Attorney Docket No. LKMP:112US
U.S. Patent Application No. 10/613,172
Reply to Office Action of March 24, 2005
Amendment and Request for Reconsideration dated: May 3, 2005

Remarks/Arguments

Fig. 2

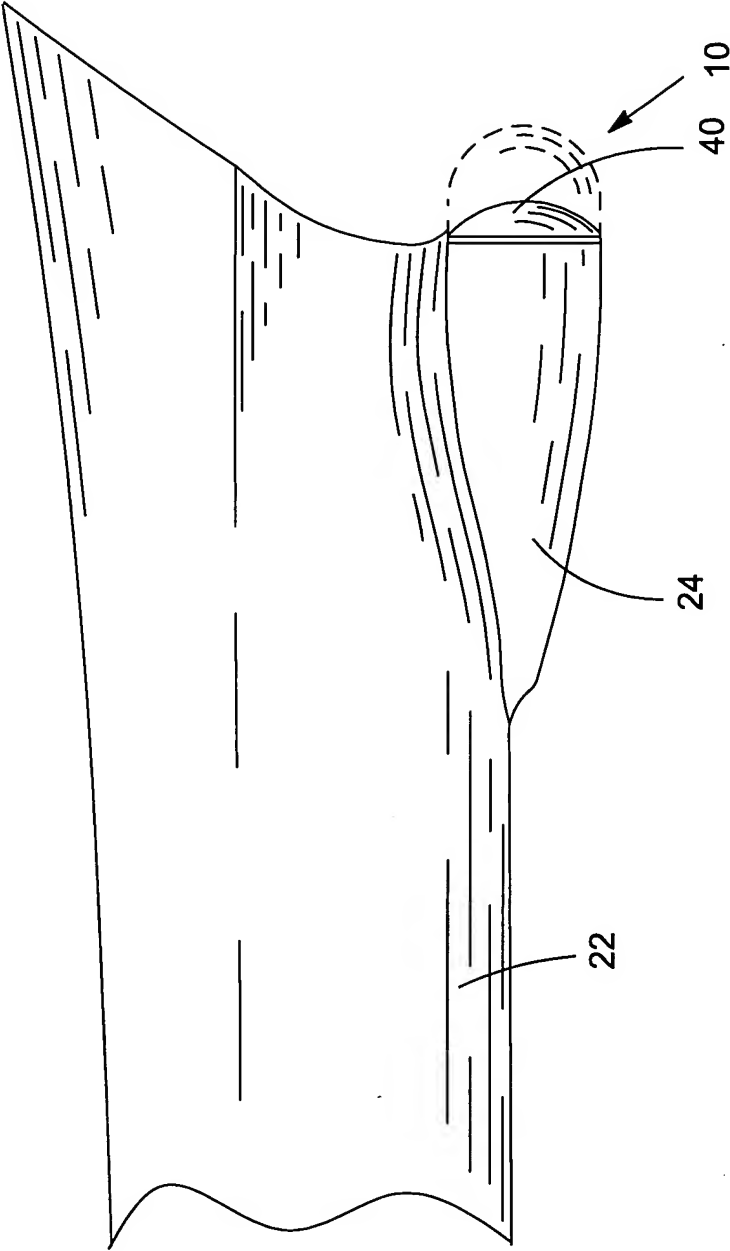
Each sheet is labeled "REPLACEMENT SHEET." A waterline has been added to and labeled in drawings 2, 8A, 8B, 9A, 9B, 10, 11, 12, 12A, 13, 14, and 15 to show the subject vessel as floating upon a water surface or being submerged below a water surface. Applicant requests that the objection be removed.

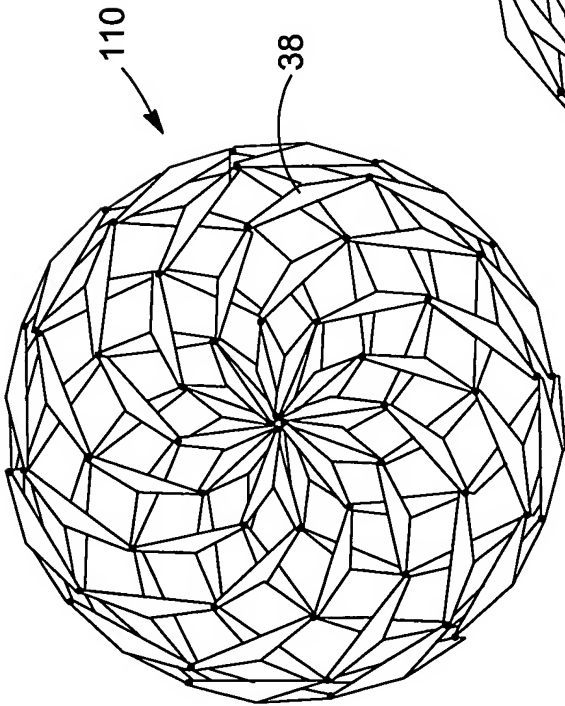
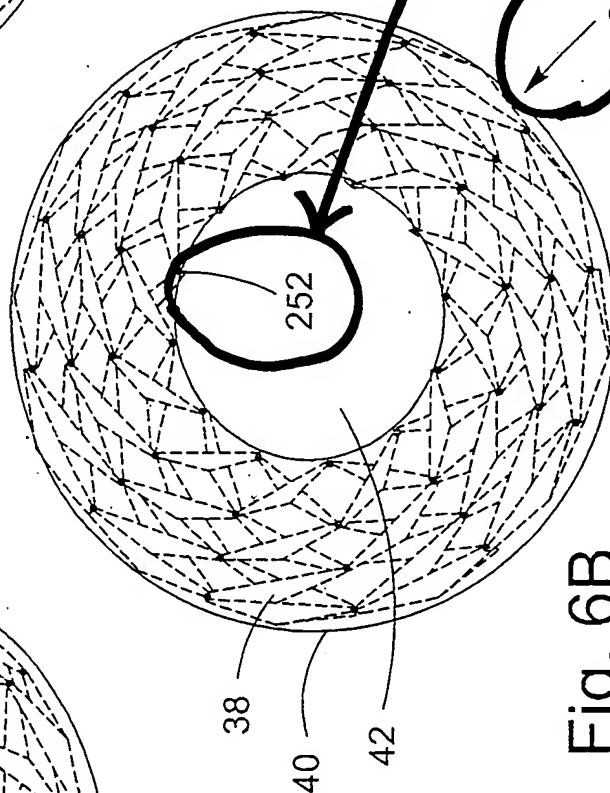
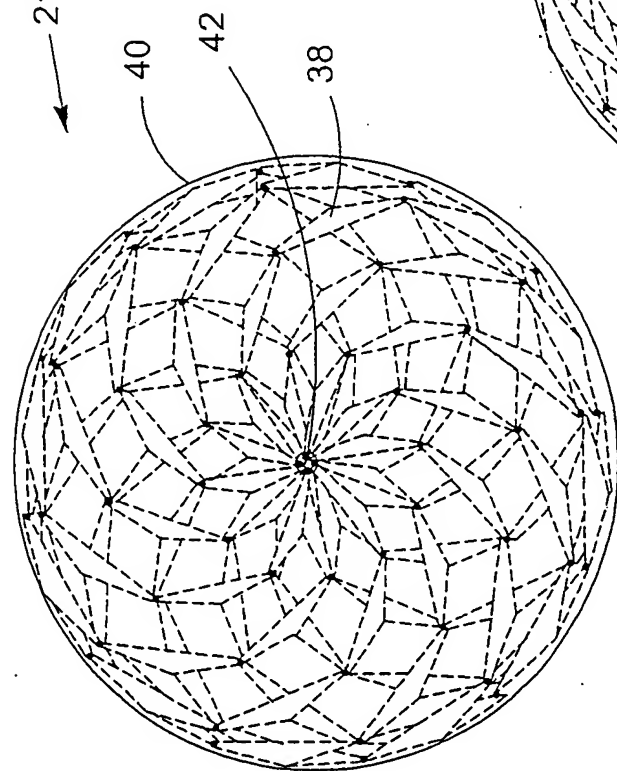
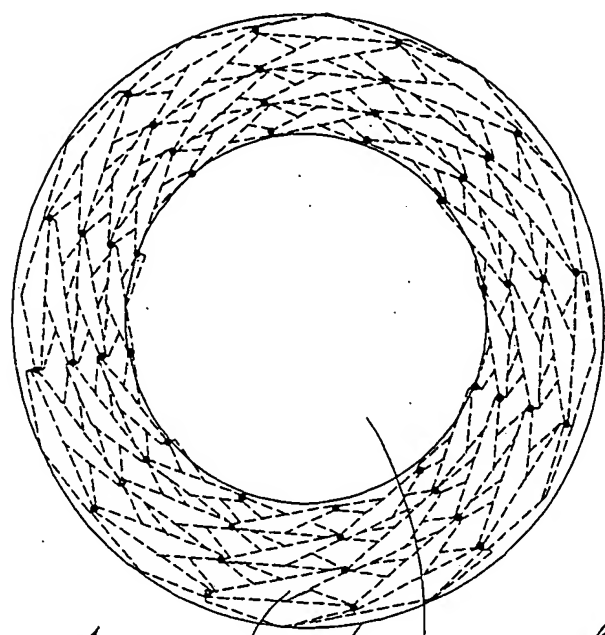
The Examiner requested that annotated sheets, showing the changes made in the Replacement Sheets provided in the reply of February 15, 2005, be provided under 37 CFR 1.121(d)(1). Applicant has provided a full set of the drawings for this purpose. The drawings are labeled “ANNOTATED SHEETS” and show the drawings as they were at the time of the August 26, 2004 Office Action response. The changes made to Figures 6A, 6B, 6C, 10, 11, 12, 12A, 13, 14, and 15 in the February 15, 2005 reply are hand marked and hand labeled.
